**Re: Inspection Report Response, April 10, 2026 Inspection
Los Angeles Regional Water Quality Control Board**

Regional Board Corrective Actions & Responses by Chiquita

Los Angeles Regional Water Quality Control Board
INDUSTRIAL STORMWATER INSPECTION REPORT
(State Water Resources Control Board Order WQ 2018-0028-DWQ, NPDES No. CAS000001)

Photo 27
Culvert with sandbags at the equipment storage area/pipe lay down yard

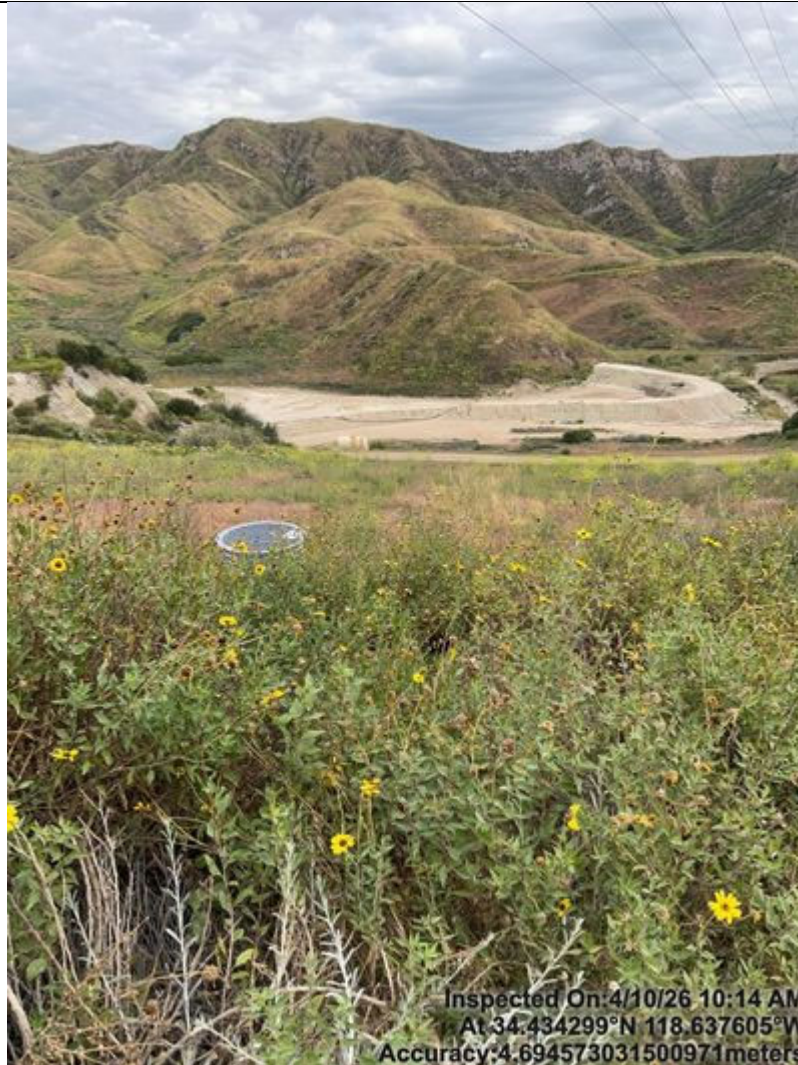
We then drove to the culvert near the equipment storage/pipe lay down yard at the existing Canyon B landfill. We saw a culvert that directs stormwater to the East Basin (Photos 27-31). I observed that the sandbags in front of the culvert were in need of repair (Photos 39-41). I also observed sediment accumulation in front of the sandbags and in the culvert (Photos 27-31, 39-41). We informed Mr. Breuer that the sandbags need to be repaired and placed properly. I also observed that the silt fence surrounding this area was installed improperly (Photos 30-38, 42). We informed Mr. Breuer that the silt fence needs to be repaired in several places and correctly installed per BMP guidelines. Near the culvert, I saw the equipment storage area and pipe lay down yard. I saw drum and tote storage outdoors without secondary containment (Photos 44-49). I saw equipment stored directly on the ground, upgradient of the culvert, without BMPs in place (Photos 50-52). I observed rusted metal material in this area (Photos 50-52). We informed Mr. Breuer that BMPs should be implemented in this area.

Photo 29
Close-up of the culvert. I observed sediment accumulation around the sandbags

- The silt fence and sand bag best management practices ("BMPs") in the Canyon B area were repaired the week of June 1, 2026 as shown in the enclosed Photos 1, 2, 3, and 4. The silt fence and sand bag BMPs are maintained as needed based upon inspection and are one of many Erosion and Sediment Control BMPs installed, maintained, and implemented at the Landfill.
- Ongoing preparations for installation of the ethylene vinyl alcohol/high-density polyethylene geomembrane cover ("EVOH cover") changed the condition of the area depicted in the Report's Photo 83 and eliminated the need for the temporary hay-bale erosion control BMP at that location. The former BMP, including the hay bales and

Photo 31

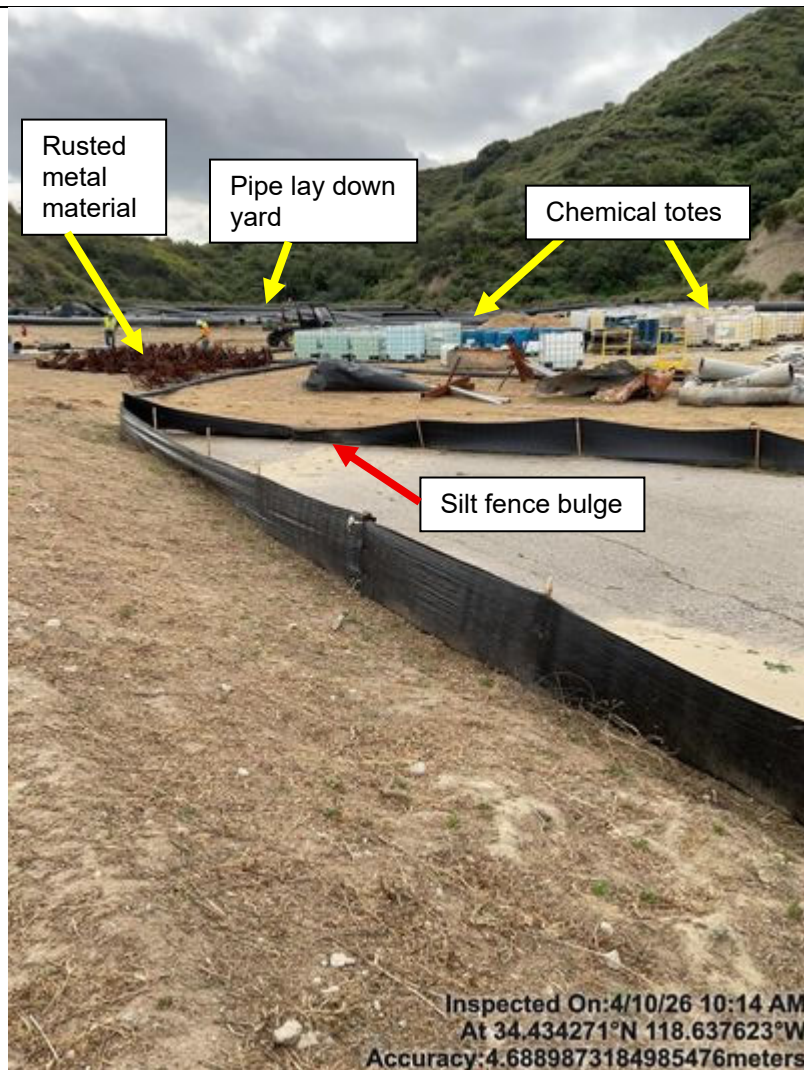
Culvert on map. Sediment accumulation in front of culvert. Sand bags in need of repair

Photo 34
Silt fence with improper installation in need of repair.

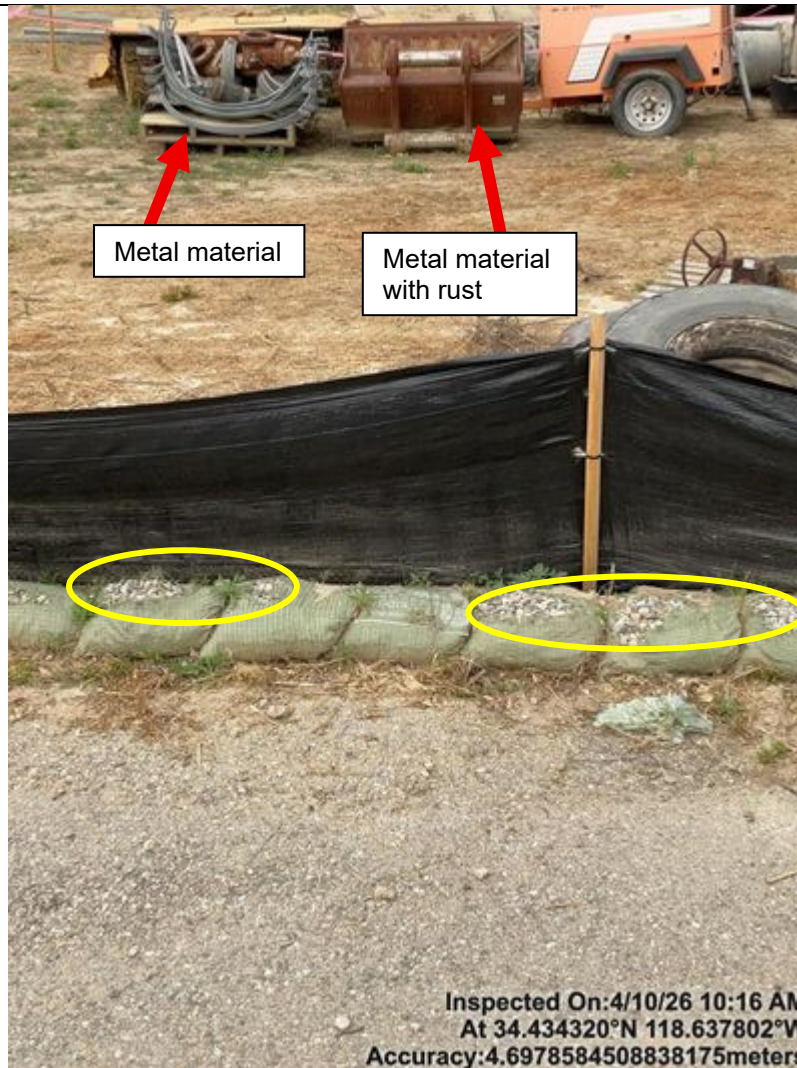
Photo 33
Silt fence with improper installation in need of repair.

Photo 82
Close-up of erosion control BMP

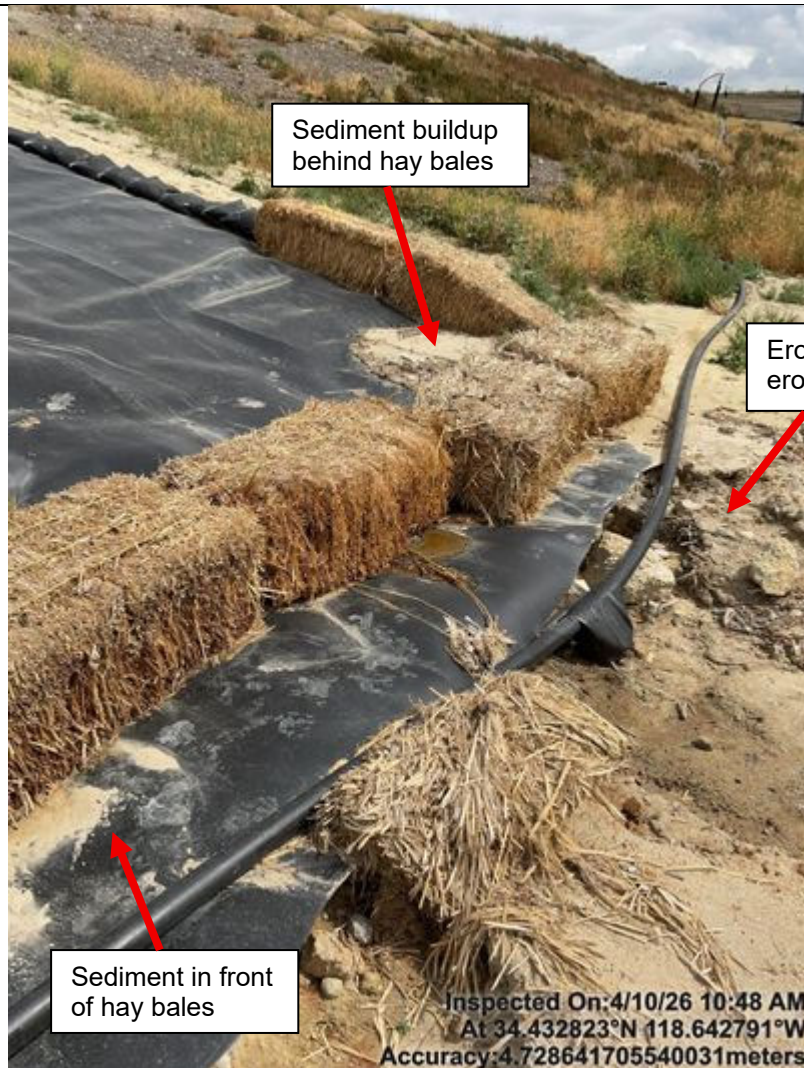
We then saw granulated activated carbon (GAC) bales outdoors (Photo 70-71). Mr. Breuer explained that GAC is used for leachate treatment. Next we drove to an erosion control BMP used to guide stormwater down the hillside (Photos 72-83). I observed erosion rills and gullies next to and under the erosion control BMP. I also observed sediment buildup behind and in front of the hay bales (Photo 83). We informed Mr. Breuer that this erosion control BMP would not be effective during a large storm event.

associated accumulated sediment, was removed by Chiquita staff prior to receipt of the Report. The current condition as of September 30, 2026, of the area is shown below. The area will be covered in EVOH soon. See enclosed Photos 5 and 6.
